Retrofit to New Style Drench Hose Valve

When utilizing the updated valve design (launched in October 2011) on older style drench hoses, it is important to know that in most applications the valve is not a direct replacement. Please review the following information to determine how to best retrofit your drench hose.

Deck Mounted Type

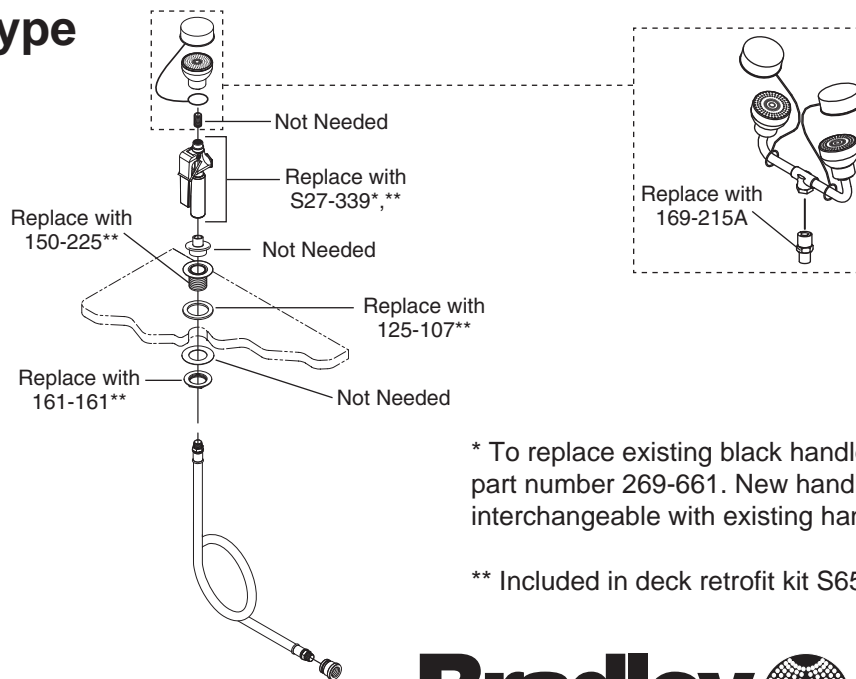
New mounting components required for new valve style. To retrofit deck mounted type, order complete kit S65-381.

** Included in deck retrofit kit S65-381.

Wall Bracket Type II

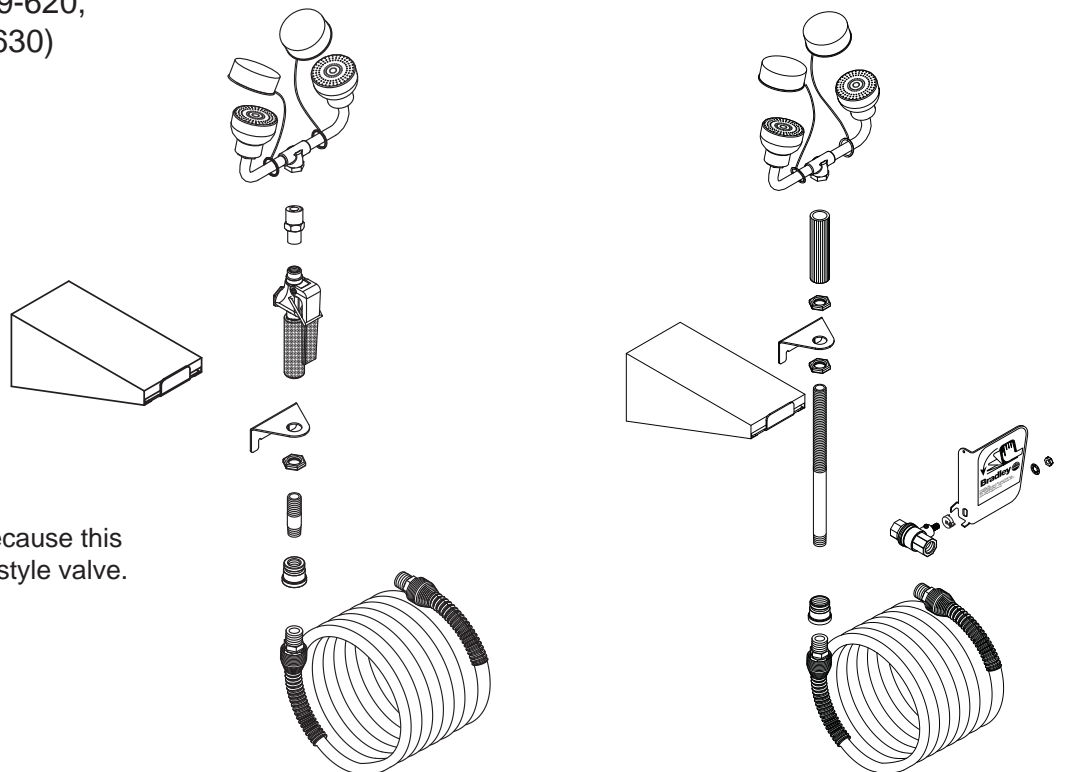
Must upgrade to new style because this bracket will not hold the new style valve.
